John Lampon Hall:

Boiler Room cupboard

FAQs:

100amp supply:

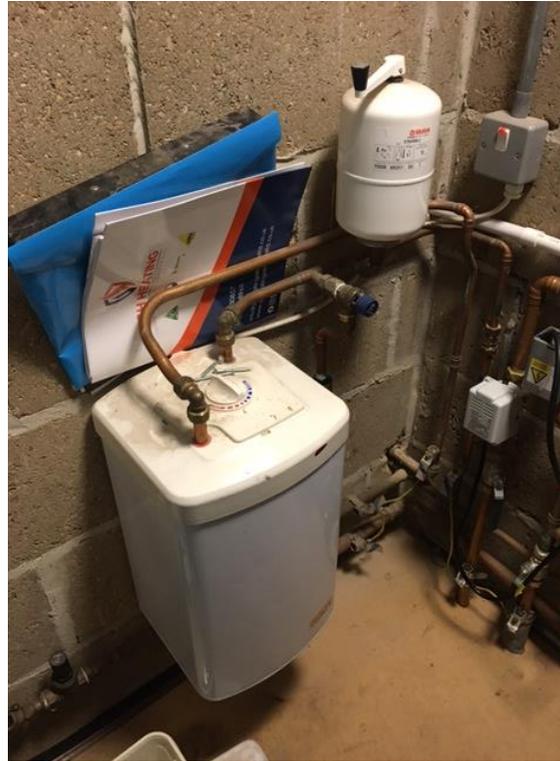
The fusebox in the internal boiler room is only a 100amp, with 6 spare supplies, but once the Hub has lights, sockets, electric heaters, fans etc. there is concern that these will all be used up with no spare. **Therefore, if the fuse box needs to be increased it will be funded outside of the contract.** Consumer unit on legend appears to be above sink in toilet in plans, if this is the case, then its positioning will be discussed at an up-and-coming meeting of the Cllrs project management team on Monday 15th July.
